**CARDINAL FREEMAN VILLAGE
137 Victoria Street, Ashfield**

**CONCEPT PLAN APPLICATION
MP 08_0245**

RESPONSE TO SUBMISSIONS REPORT

**Prepared for
Aevum Limited**

Emergency Vehicles Turning Paths

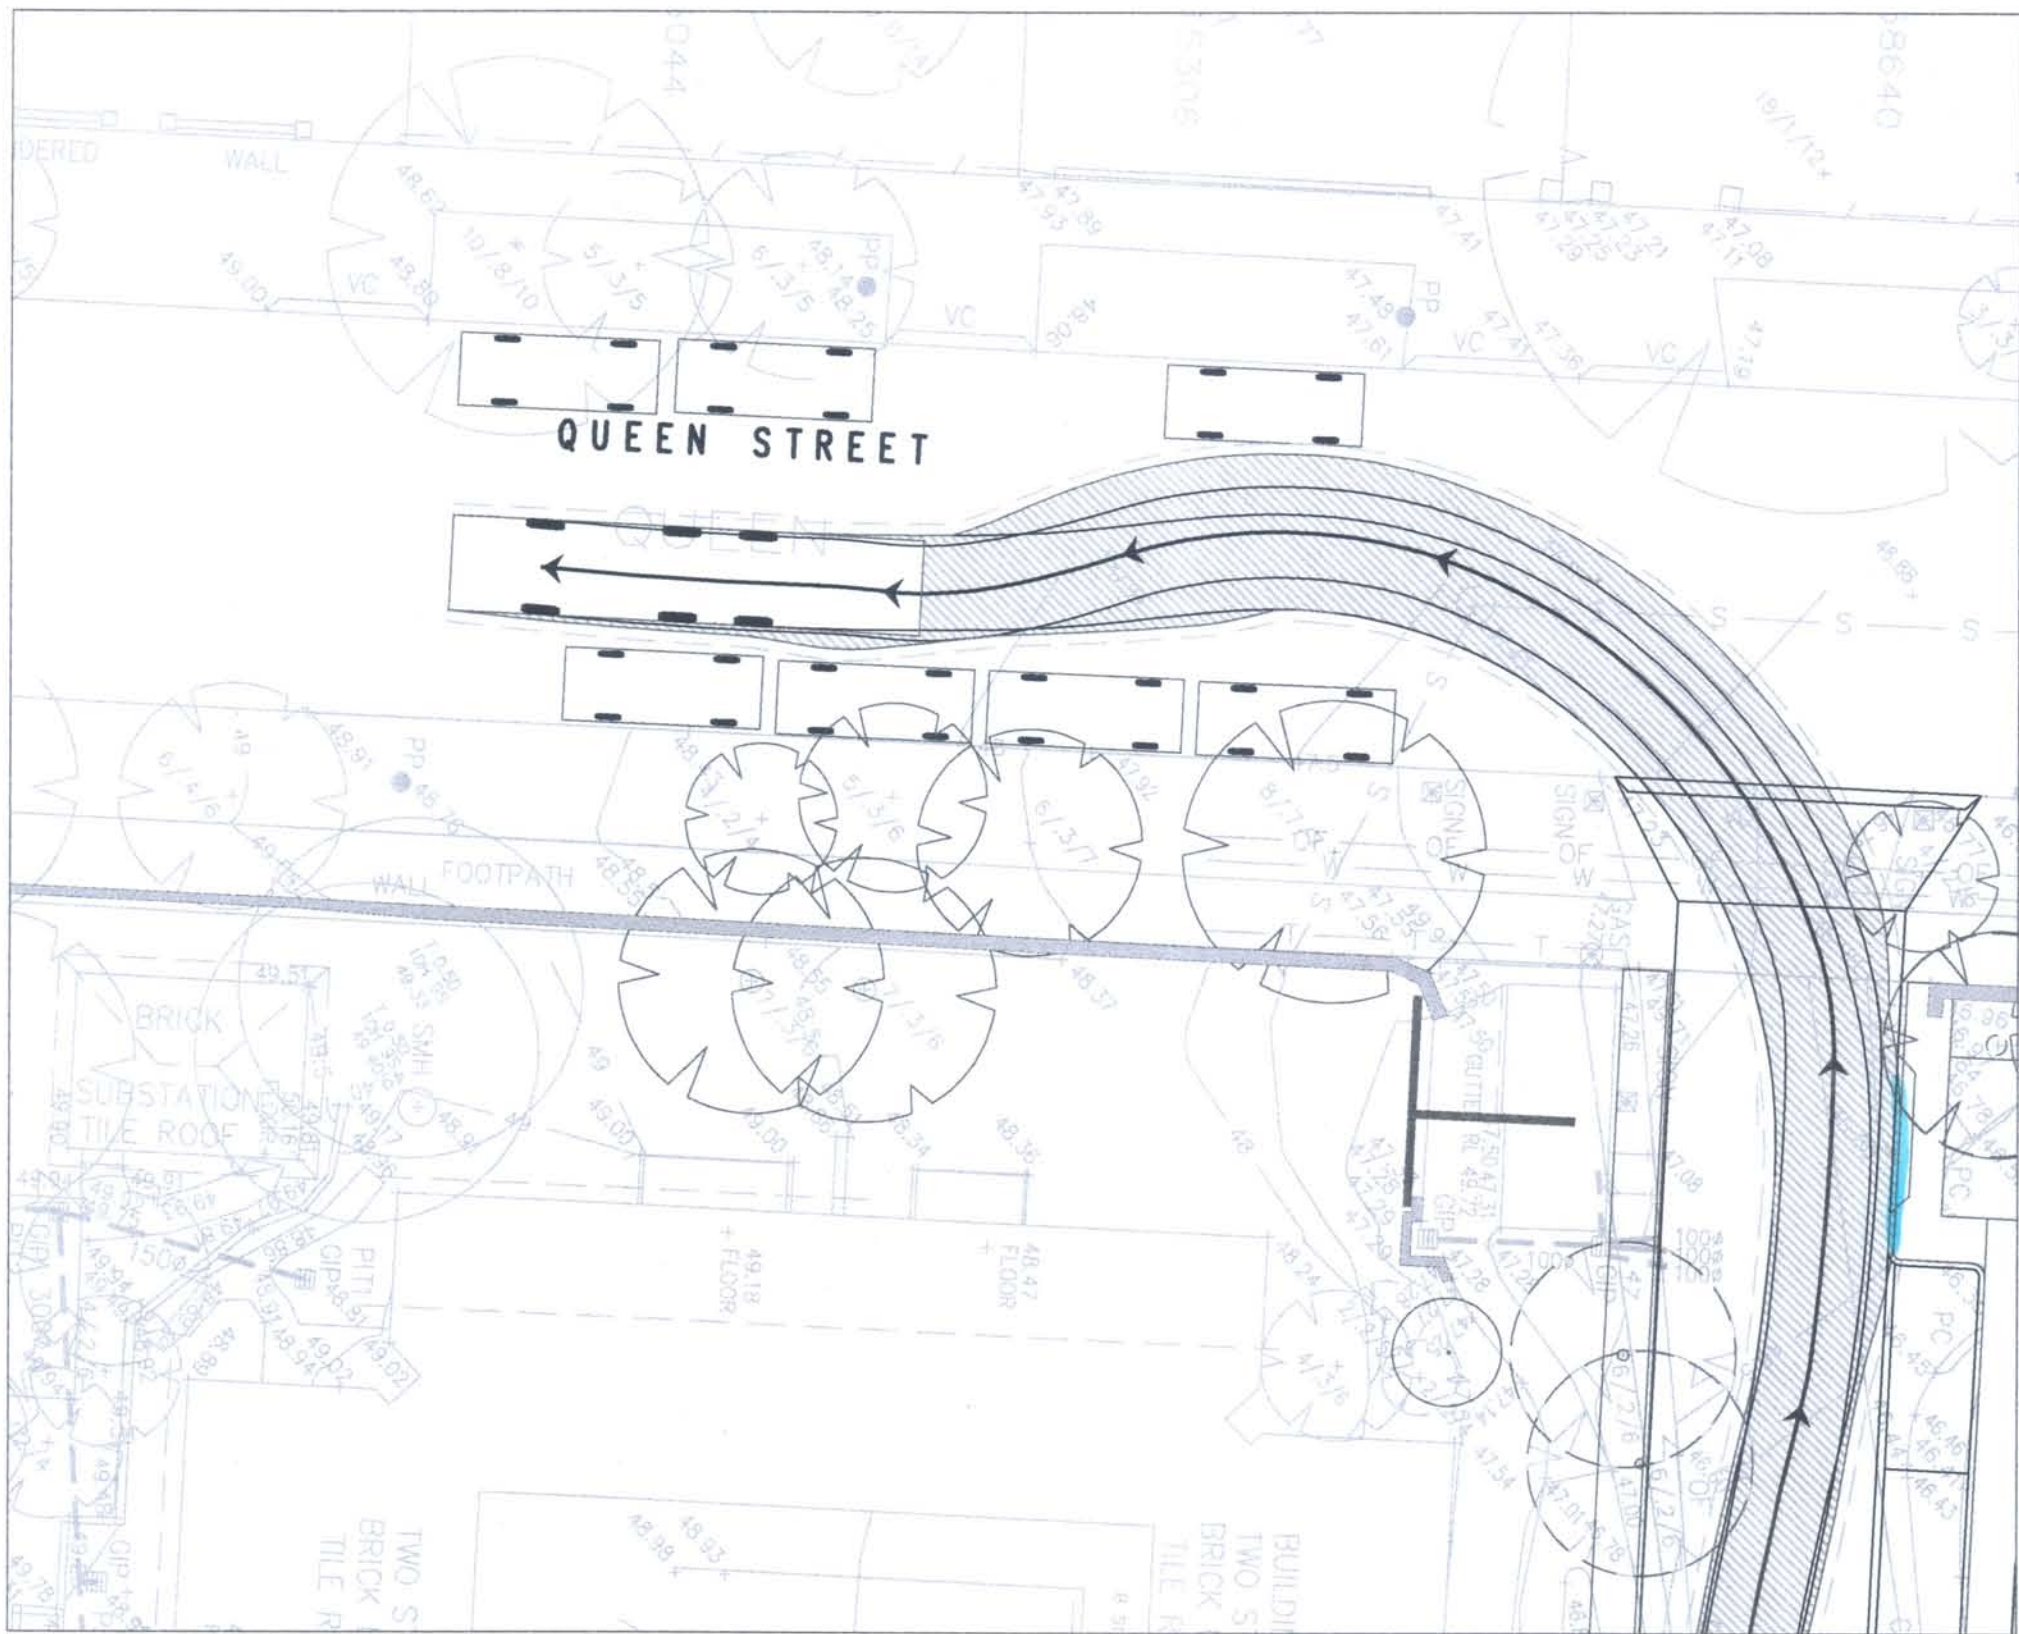
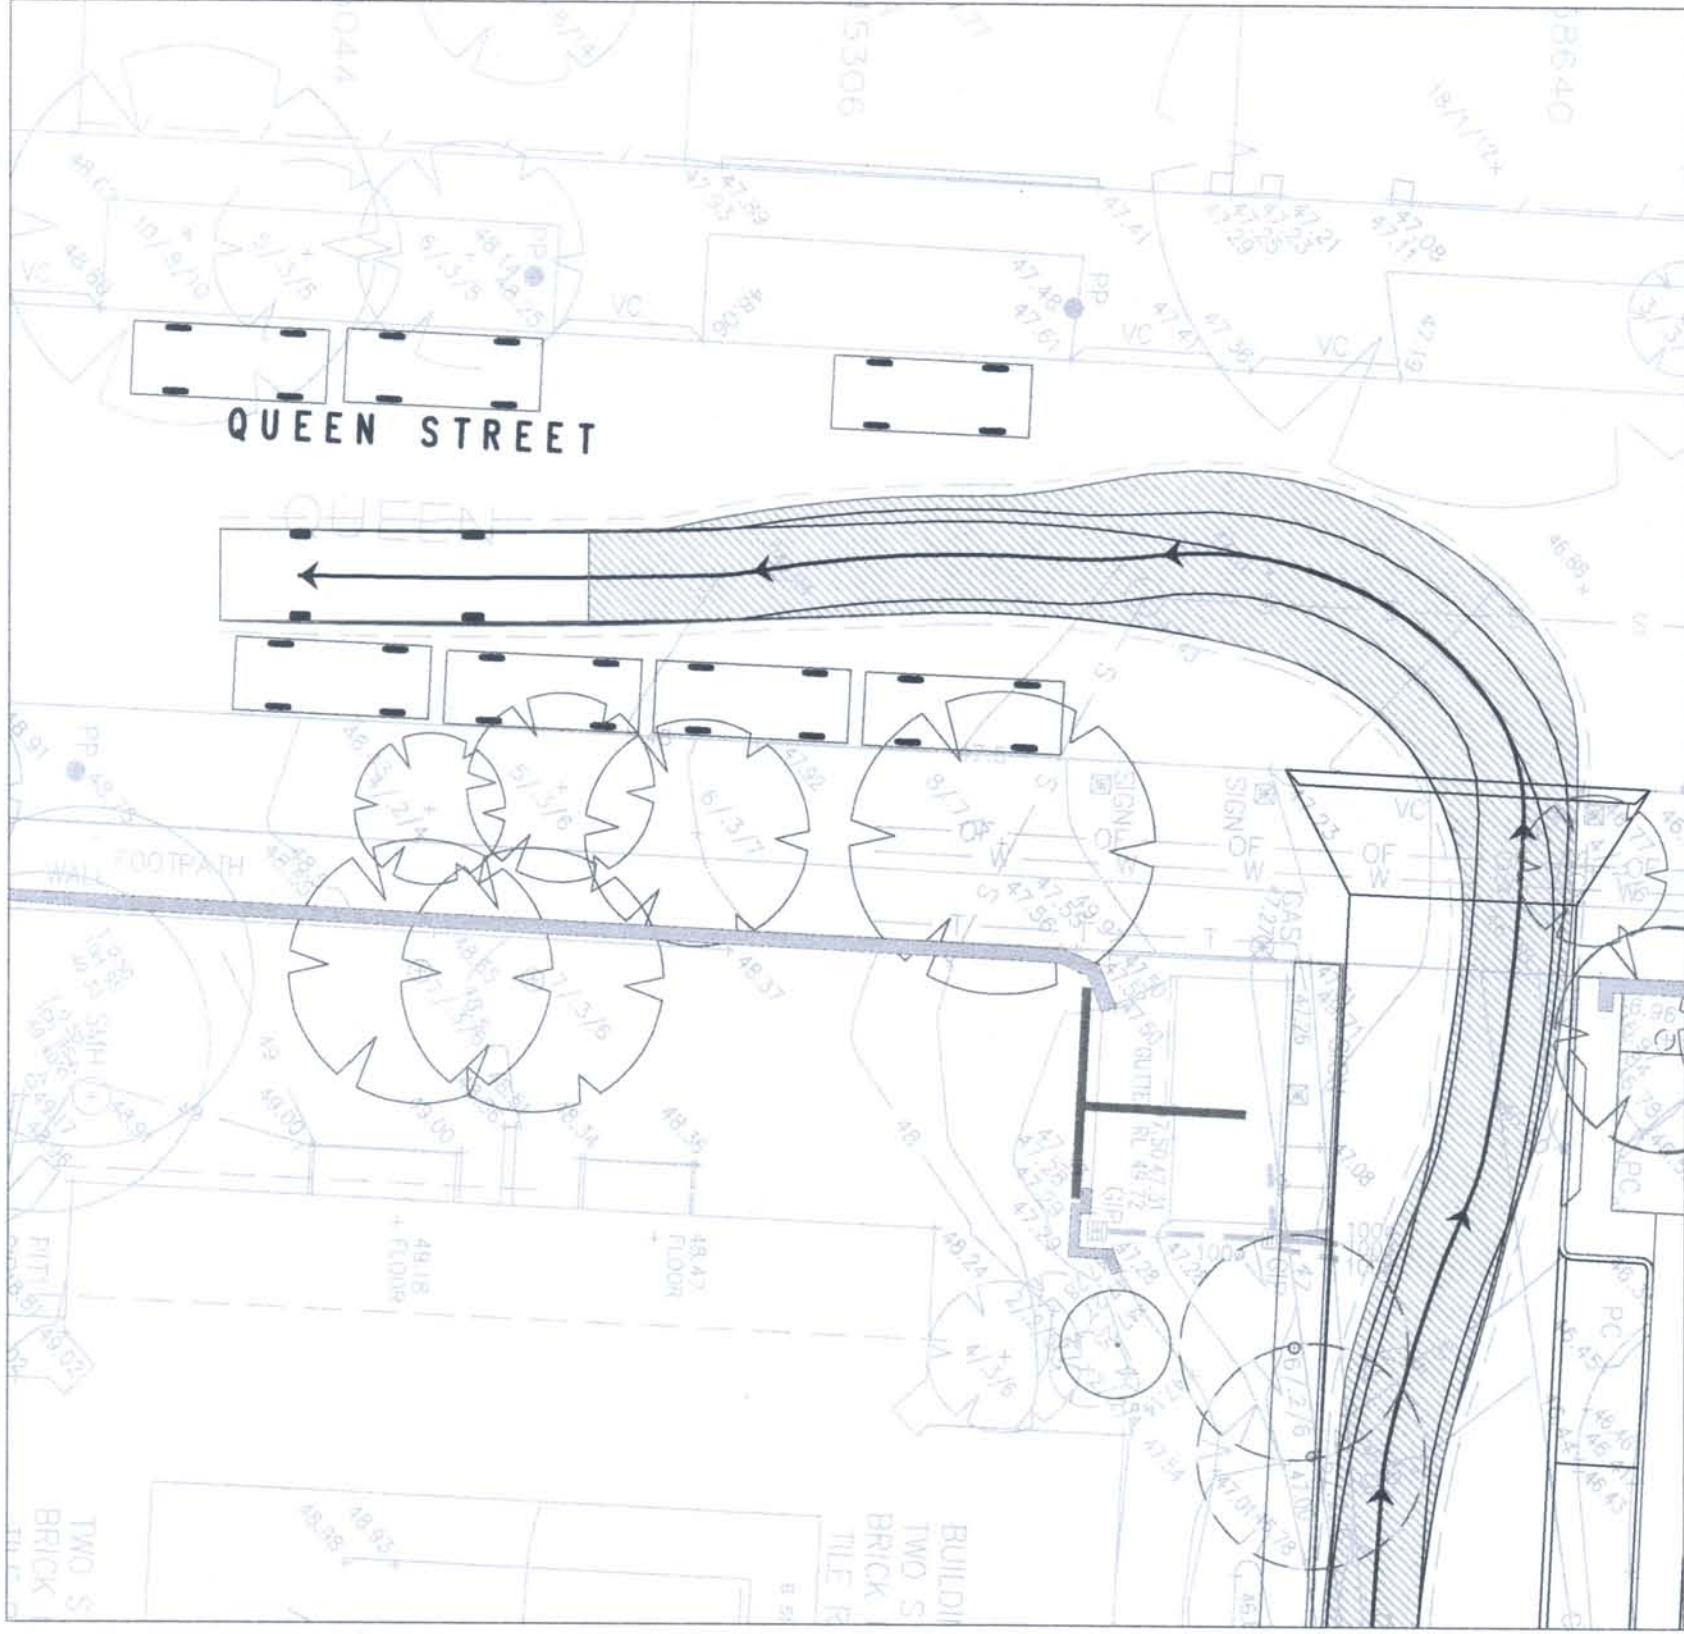
The Department has requested plans that illustrate how emergency vehicles may access the site in accordance with the NSW Fire Service Guidelines for Emergency Vehicle Access.
